CITY OF OREGON CITY HISTORIC REVIEW BOARD AGENDA

Virtual Meeting
Tuesday, January 25, 2022 at 7:00 PM

Staff Report

GLUA 21-00061 / HR-21-00024: Historic Review for New Construction at 724 Polk Street, site of the Clark S. Fuge residence, a historic landmark site.

DRAWN
CHECKED
DATE 5/23/21
SCALE 1"=10' / 1/8"=1'
JOB NO.
SHEET 1/4
OF SHEETS

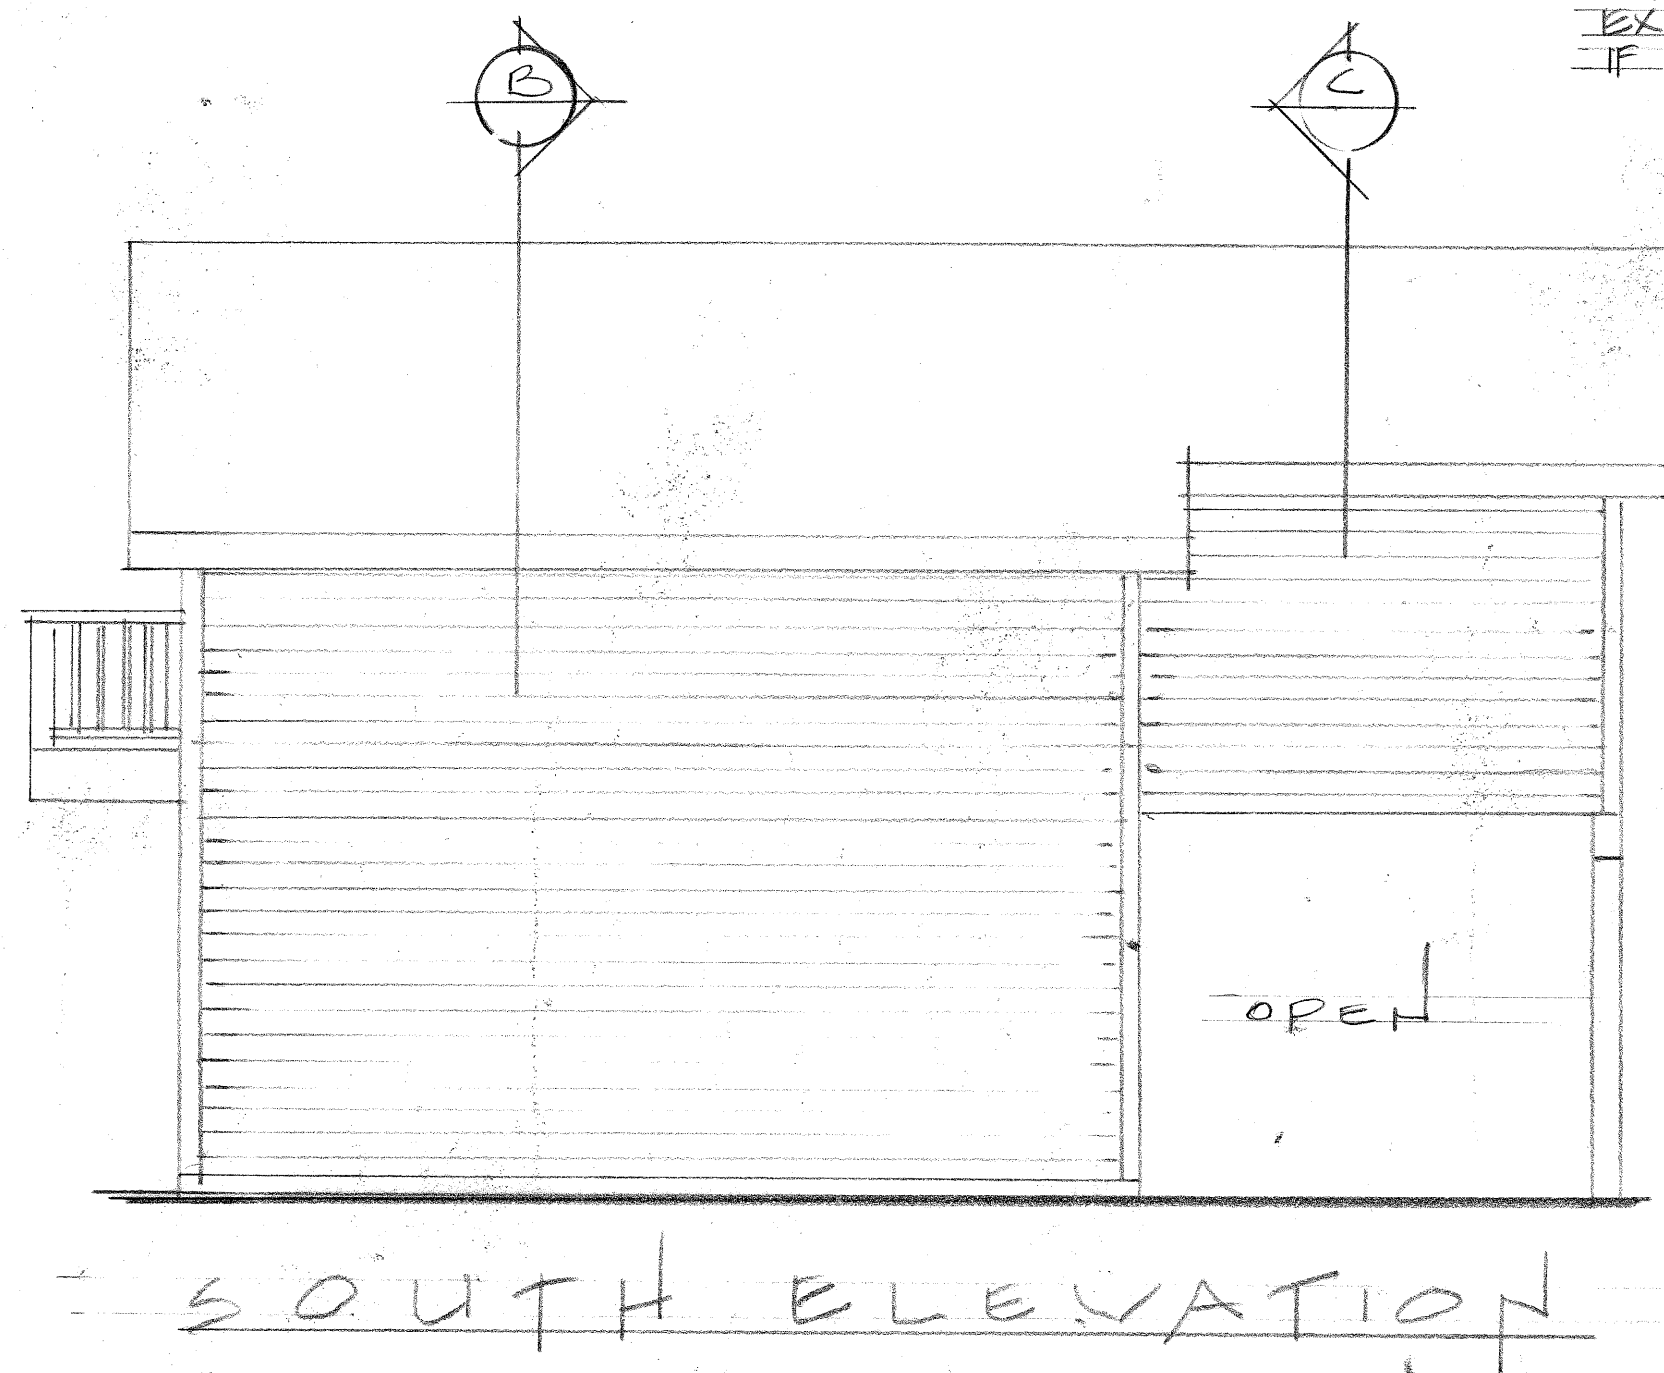
You have a note on the plans – “confirm window size” – do you have a proposed size for that window?

Your plans indicate a 2x2 skylight on the rear roof plane of the dormer if no window is included in the dormer – is that right?

Proposed window is 2” by 2’-6” . This could change in heigth when roof is attached.

Yes. But recent calculations show we will be using a window, so skylight will not be necessary.

FRONT ELEVATION
1/4" = 1'-0"

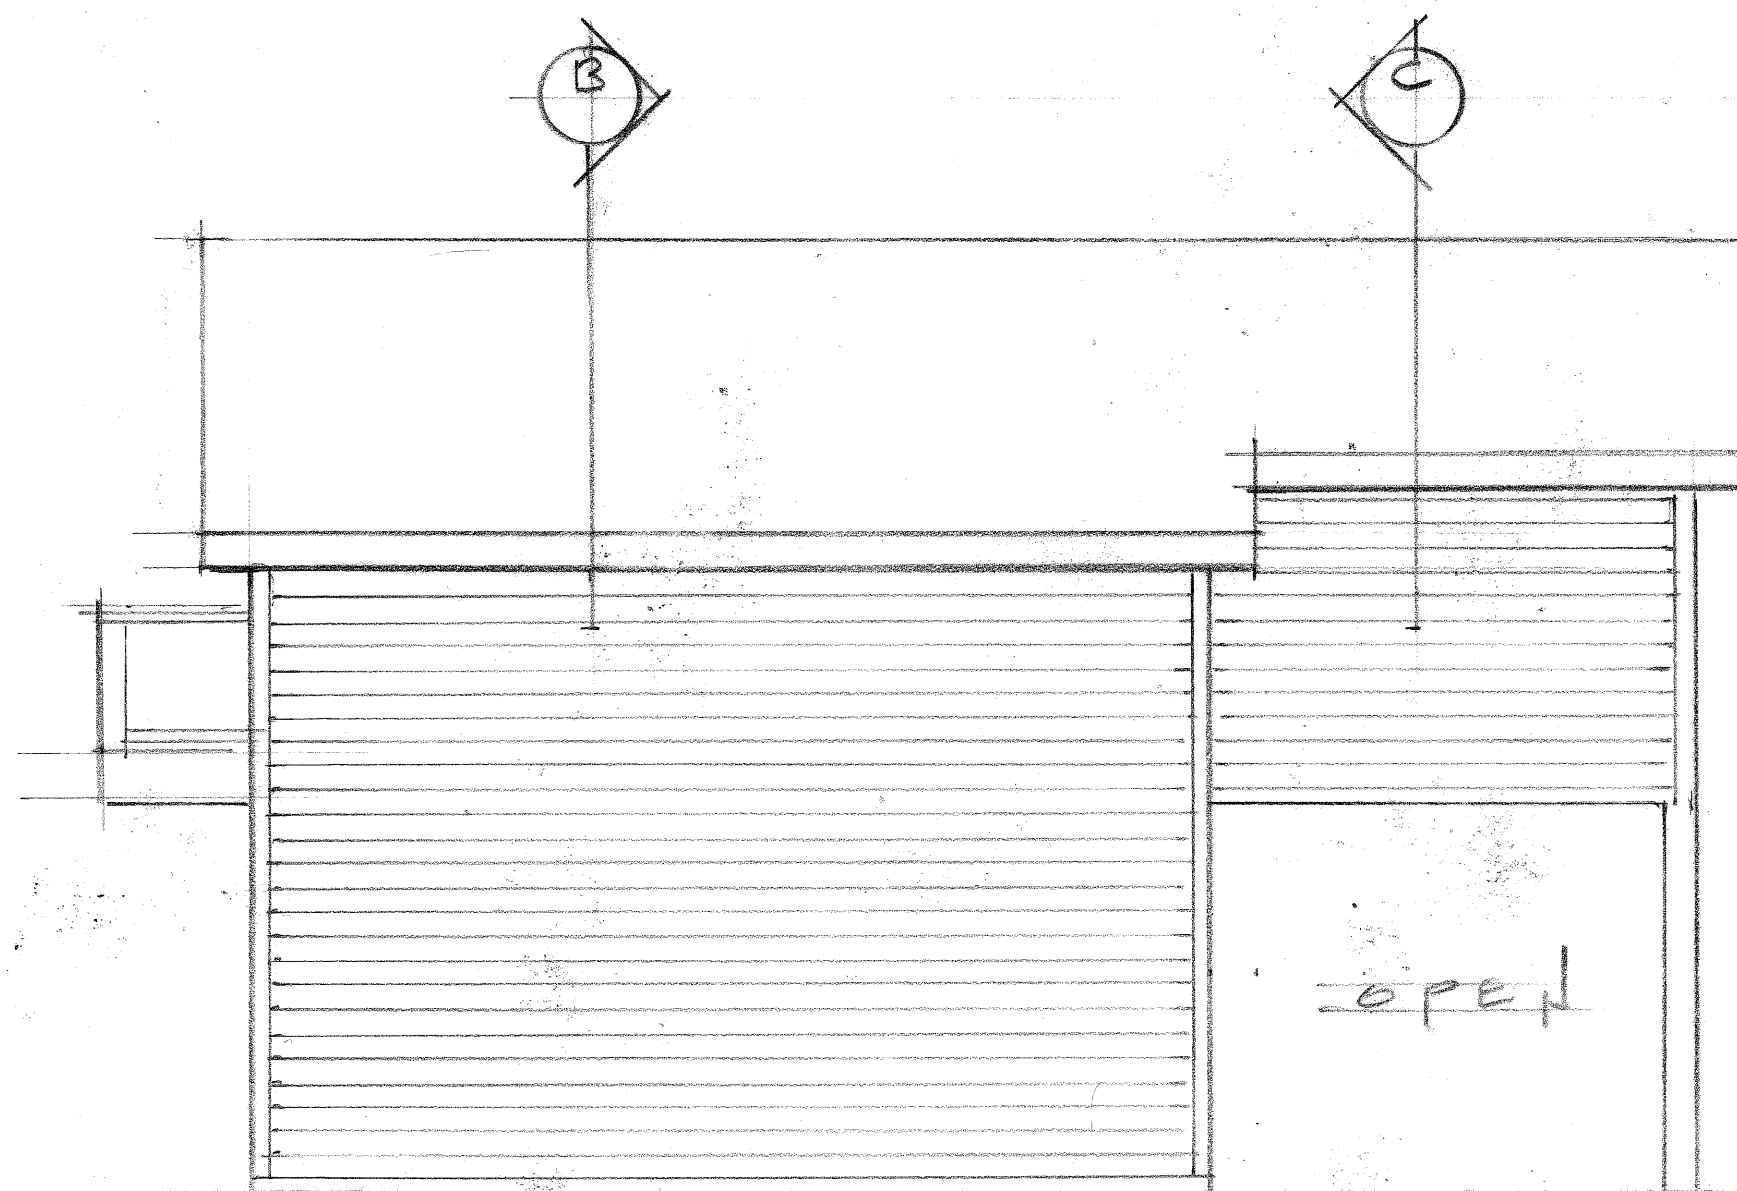
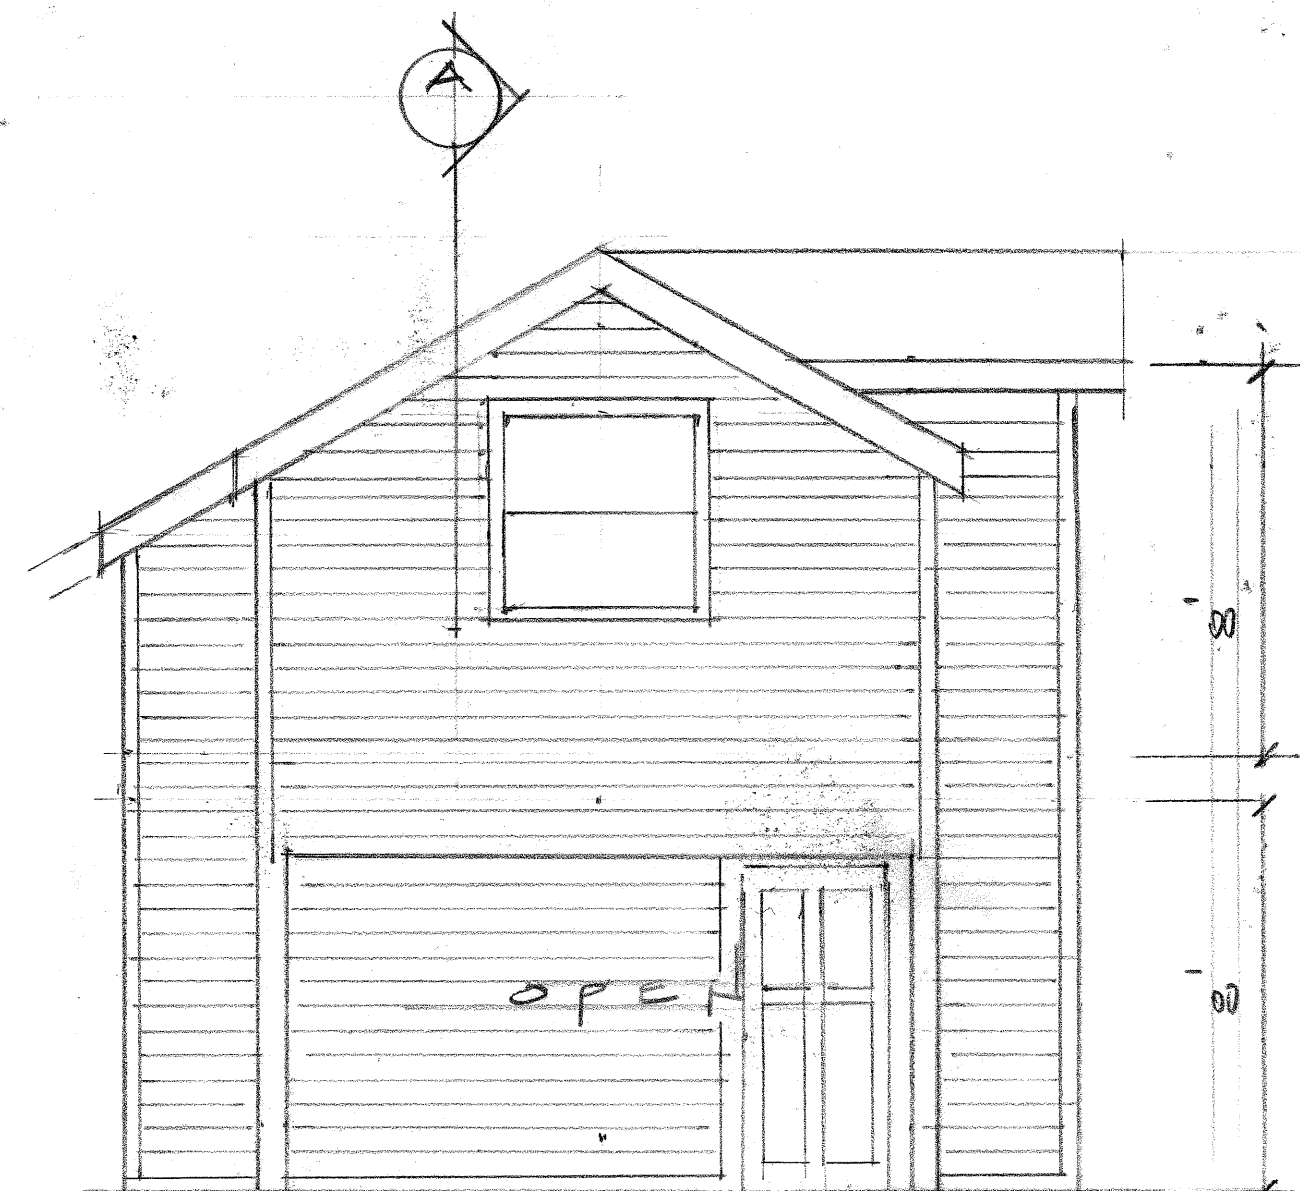
The south elevation (side) has no windows and is fairly plain. However, as an accessory structure and a side façade that is not facing the right of way and 36 feet back from the sidewalk, windows on this façade would not provide much exterior aesthetic benefit and would not affect the structure's impact on the Fuge residence.

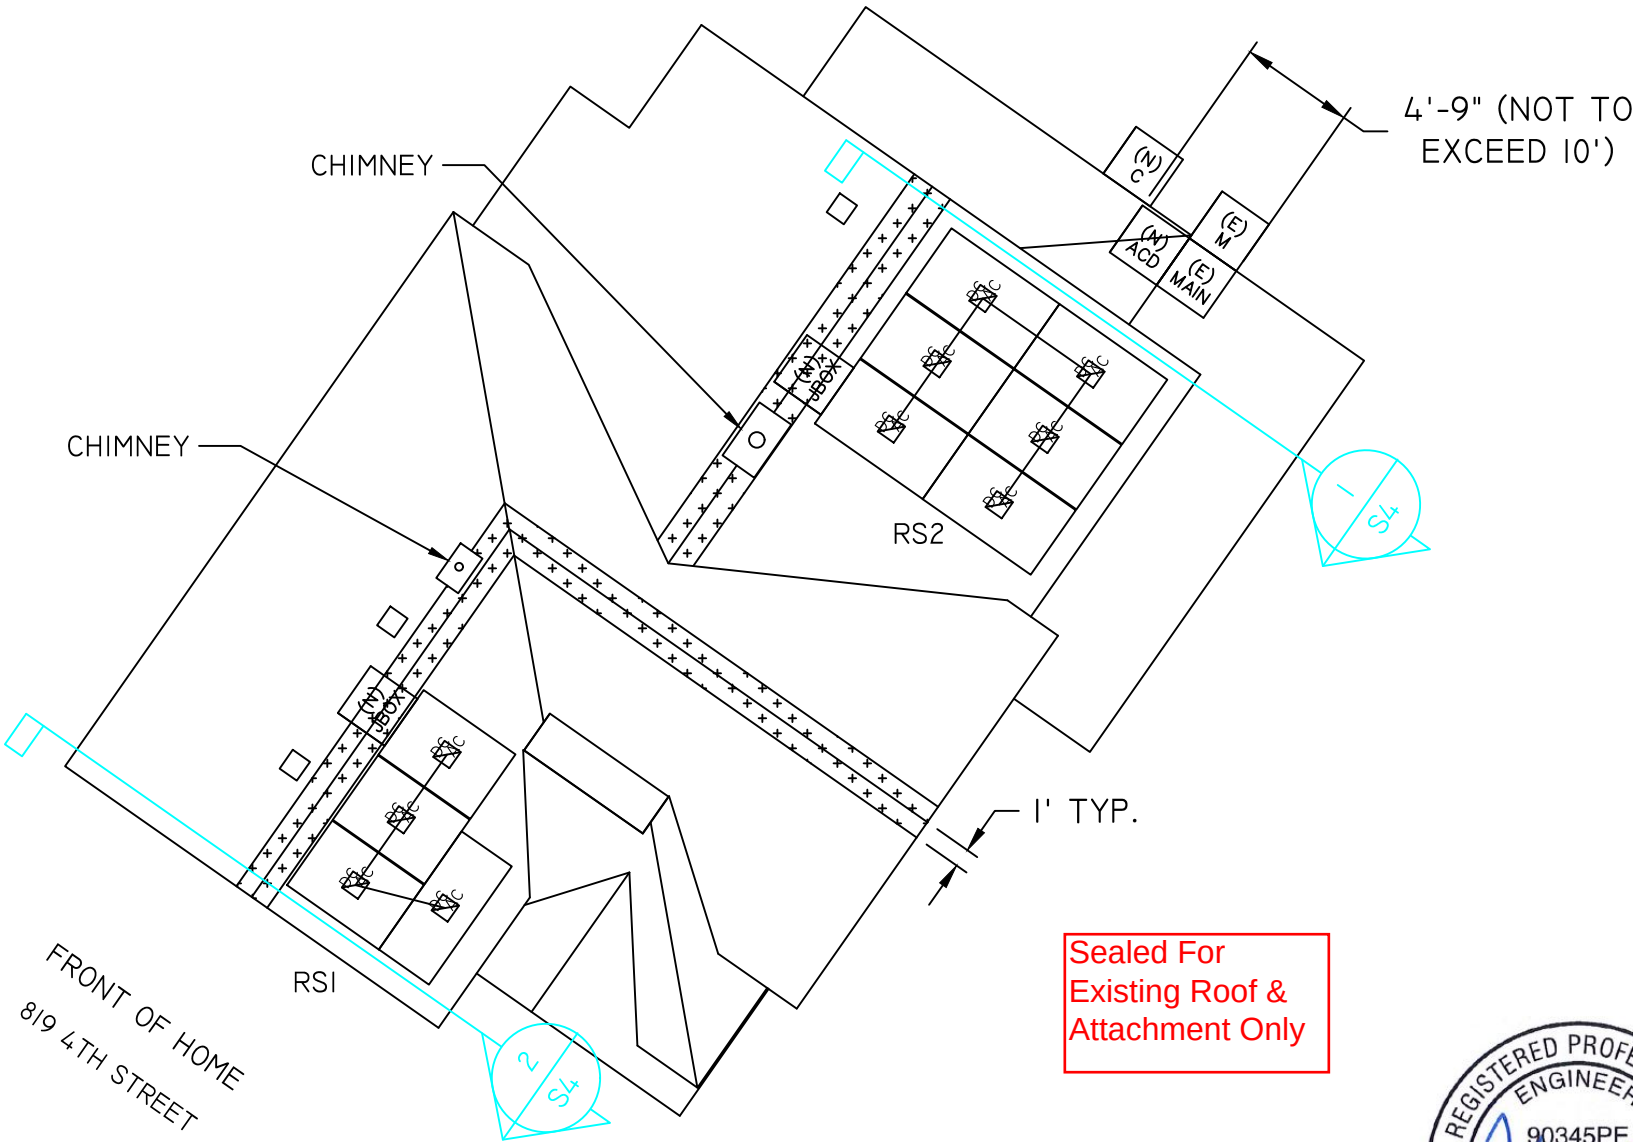
Design/Detail Compatibility Analysis: The panels are flat on the roof and appear to be low profile. If approved, a condition of approval to ensure the panels do not exceed 5" projection from the roof plane should be considered.

Arrangement/Proportion/Scale Compatibility Analysis: Panels are placed a few inches from the edge of the roof and fill up most of the roof plane in question. The applicant did not provide the square footage of the panel array or indicate the percentage of roof plan that would be covered.
